**MINUTES  
BOARD OF BUILDING STANDARDS/  
ARCHITECTURAL BOARD OF REVIEW/SIGN REVIEW  
REVIEW MEETING  
CITY OF LAKEWOOD  
12650 DETROIT AVENUE  
AUDITORIUM  
AUGUST 11, 2022  
5:30 P.M.**

**ARCHITECTURAL BOARD OF REVIEW**

**Docket No. 08-56-22 (18425 Detroit)**

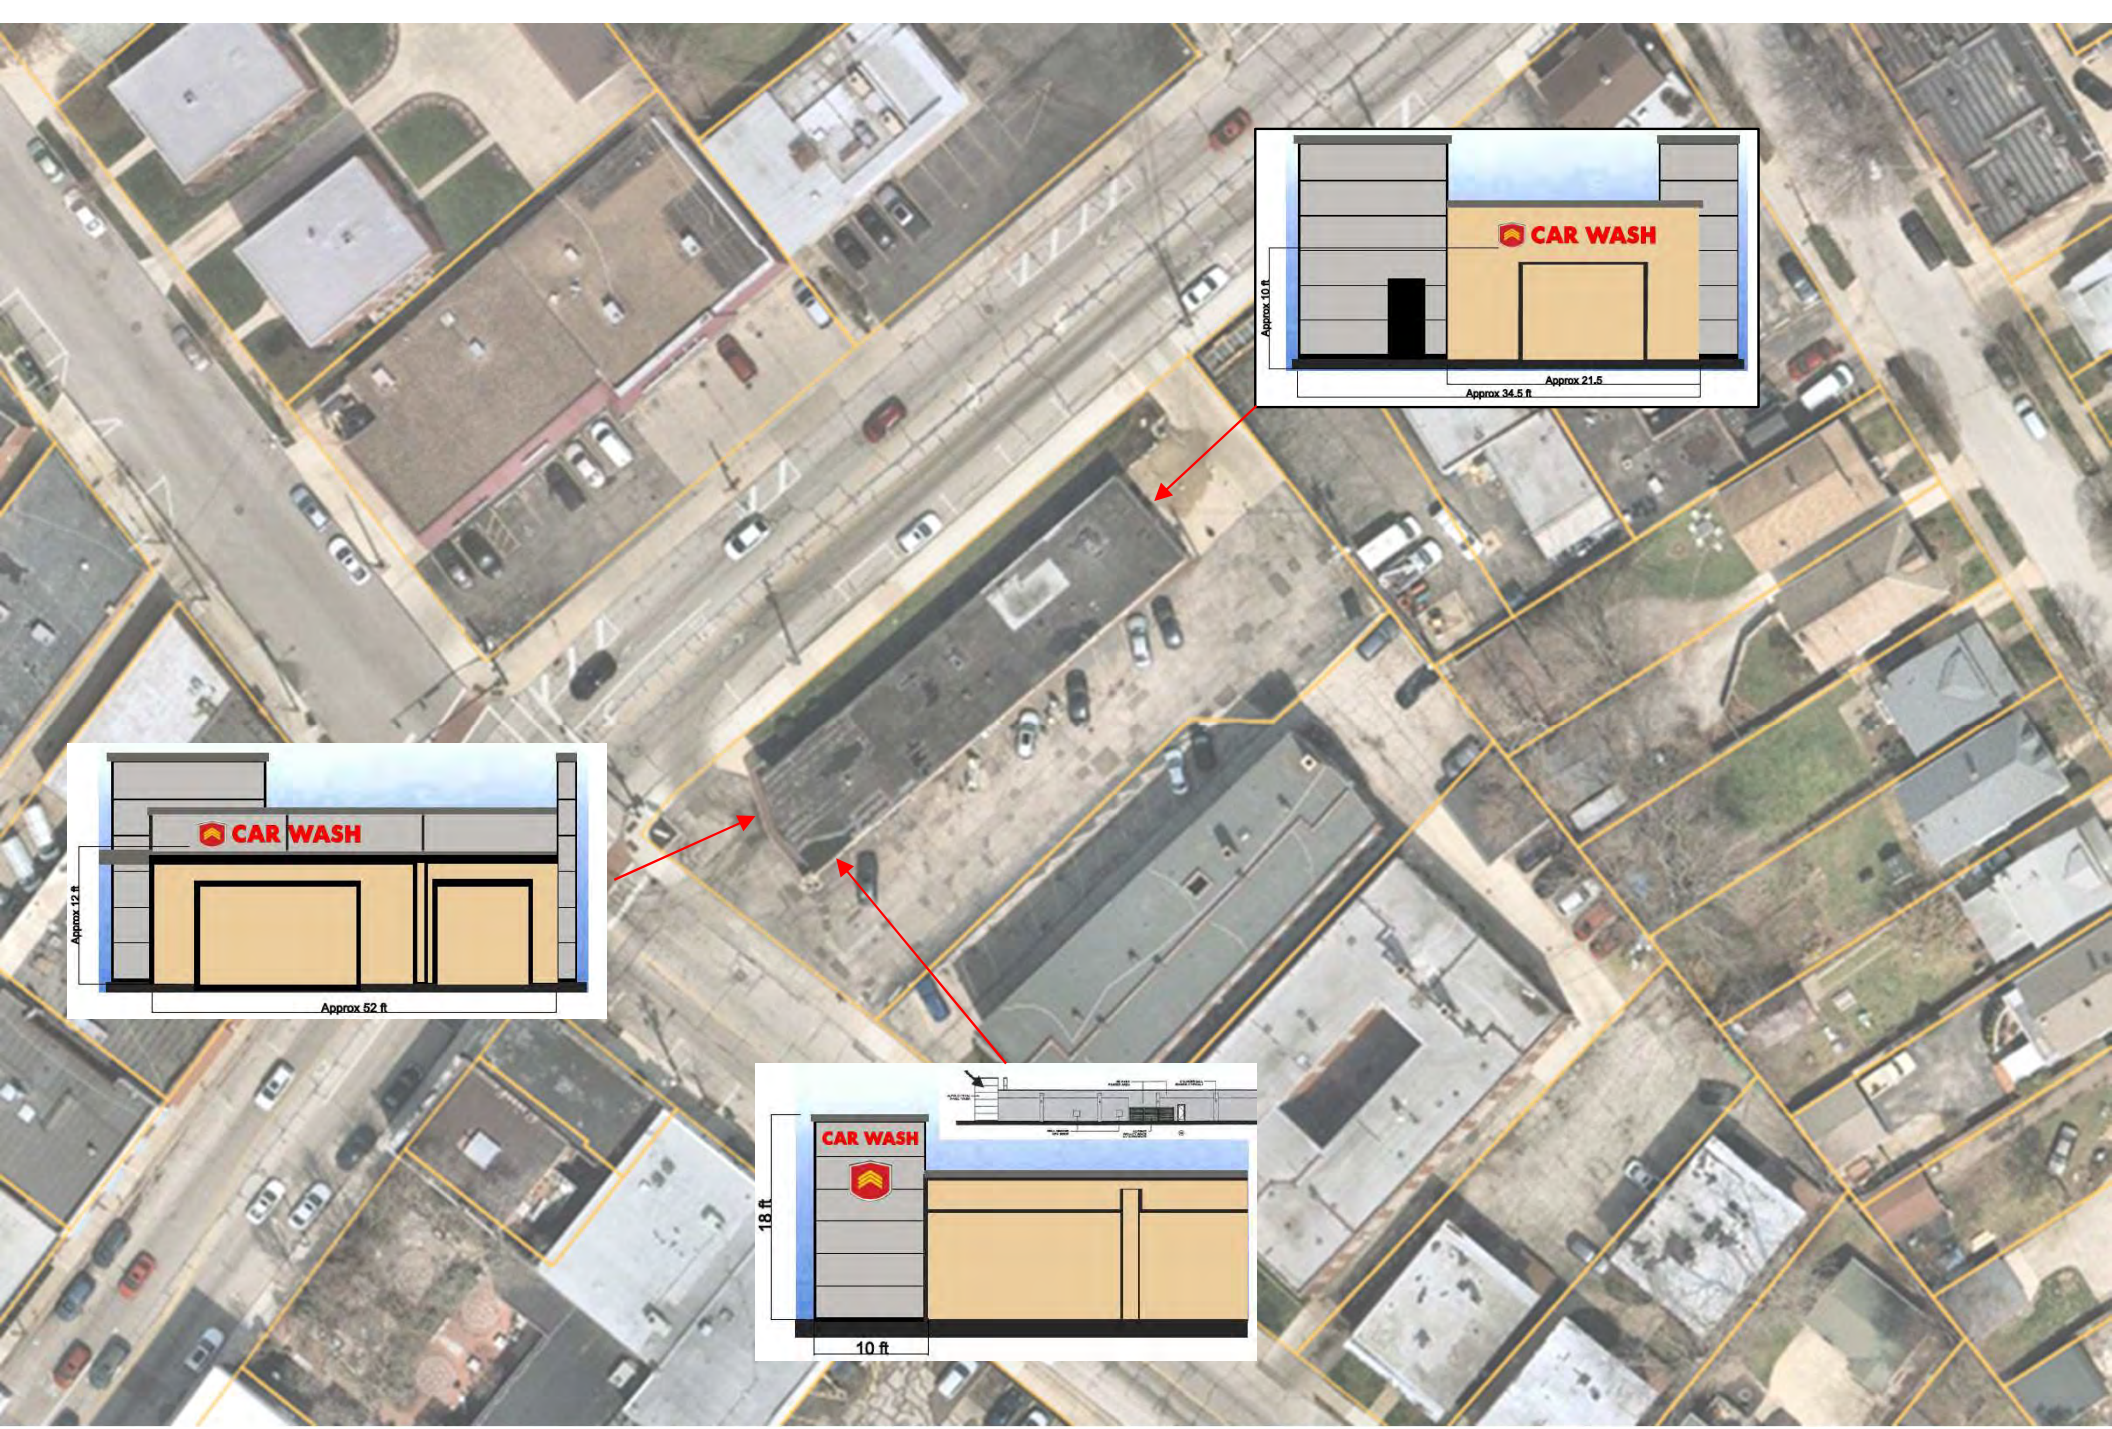
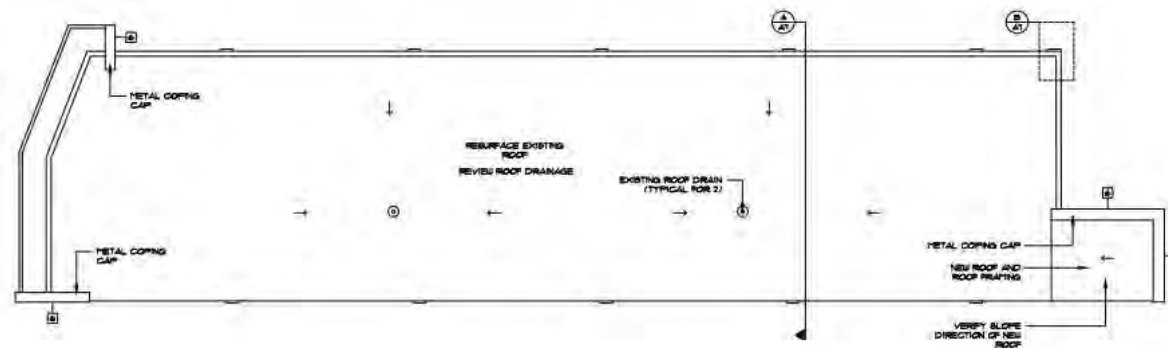
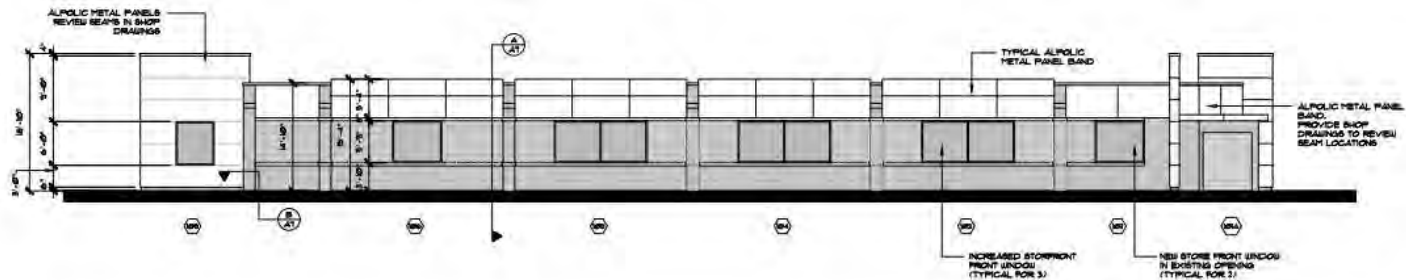
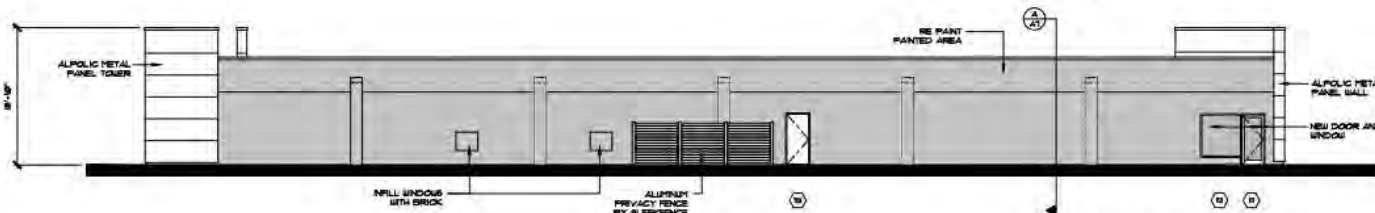
Dean Schramm, Schramm Signs, applicant, and Brian Krusz, business owner, were present to explain the request. Discussion ensued about the lack of "Sgt. Clean" words on the building mounted signs, the existing pole sign (remove it because it was non-permitted per city code), the replacement of a monument sign was permitted, "CAR WASH" was part of the brand. Public comment was closed as no one addressed the item. Staff do not receive any communication.

- ❑ Maximum allowable sign area of ~100 ft<sup>2</sup>
- ❑ Proposal is for internally-illuminated wall logos/lettering (~70 ft<sup>2</sup>) on entry, exit, and tower.
